There is often confusion regarding VFF476 Fuel Filter fitted to vehicles using the PSA 1.6 HDI engine as it is sometimes seen as not being the same as the filter removed from the vehicle.

Motaquip Product Support

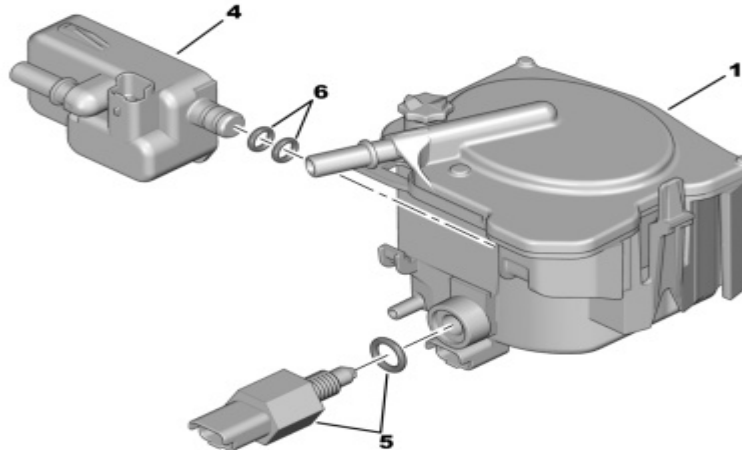
This is due to the technician not realising that the water heater module **(4)** has to be carefully removed from the old filter **(1)** and fitted on the new filter using the two new O rings **(6)** supplied.

In addition if the filter is an early type it previously had the "water in fuel" sensor built into the filter but following a production modification this is now supplied as a separate part item **(5)** below. In the event that a filter is removed from an early vehicle without the separate sensor it will be necessary to obtain this part number 191311 from a Peugeot/Citroen dealer.

Please note that when fitting this sensor it is designed to break through the blanking plug at the bottom of the sensor location on the filter.
